AMENDMENT OF SOLICITATION/MODIFICATION OF CONTRACT				1. CONTRACT ID CODE J		PAGE 1 OF 2	
2. AMENDMENT/MODIFICATION NO. 0002		3. EFFECTIVE DATE 13 June 2003		4. REQUISITION/PURCHASE REQ. NO.		5. PROJECT NO. (If applicable)

14. DESCRIPTION OF AMENDMENT/MODIFICATION (Organized by UCF section headings, including solicitation/contract subject matter where feasible.) PROJECT: FY03 SURVIVAL EQUIPMENT SHOP, HOLLOMAN AIR FORCE BASE, OTERO COUNTY, NEW MEXICO 1. This is Amendment No. 2 to Solicitation No. DACA47-03-R-0017; 22 May 2003. The following revisions shall be incorporated into the specifications and drawings. All other provisions shall remain unchanged.							
Except as provided herein, all terms and conditions of the document referenced in Item 9A or 10A, as heretofore changed, remains unchanged and in full force and effect.							
15A. NAME AND TITLE OF SIGNER (Type or print)				16A. NAME AND TITLE OF CONTRACTING OFFICER (Type or print)			
15B. CONTRACTOR/OFFEROR (Signature of person authorized to sign)		15C. DATE SIGNED		16B. UNITED STATES OF AMERICA BY (Signature of Contracting Officer)		16C. DATE SIGNED	
NSN 7540-01-152-8070 PREVIOUS EDITION UNUSABLE				30-105-02		STANDARD FOR

SURVIVAL EQUIPMENT SHOP LIFT STATION DRY WELL MODIFICATION PLAN

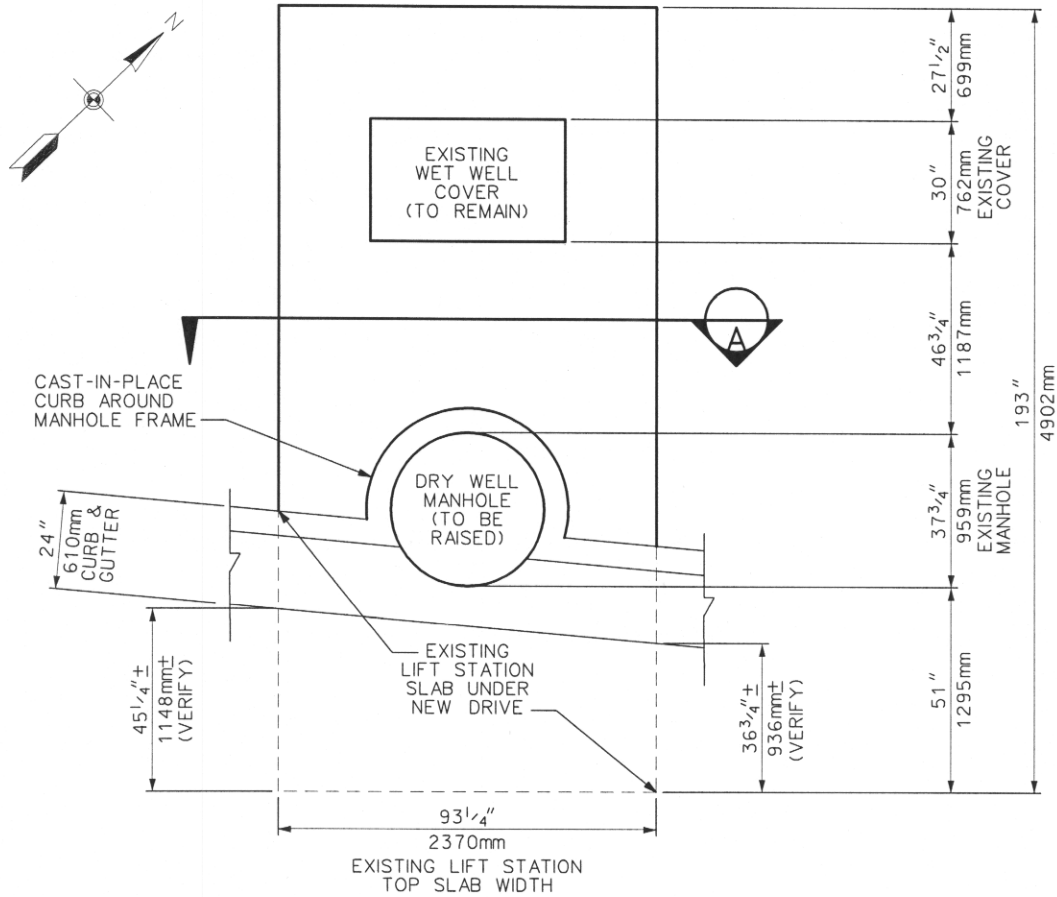
a. Sequence No 6, Sheet No. C4, SITE PLAN. Delete Keyed Note No. 14 in its entirety and replace with the following: "14. New curb around existing dry well manhole of existing sanitary sewer lift station. See Sheet C10 and "Survival Equipment Shop Lift Station Dry Well Modification Plan" drawing for details."

b. Sequence No. 12, Sheet No. C10, UTILITY DETAILS - II. Add detail "Survival Equipment Shop Lift Station Dry Well Modification Plan", attached hereto, to Sequence No. 12.
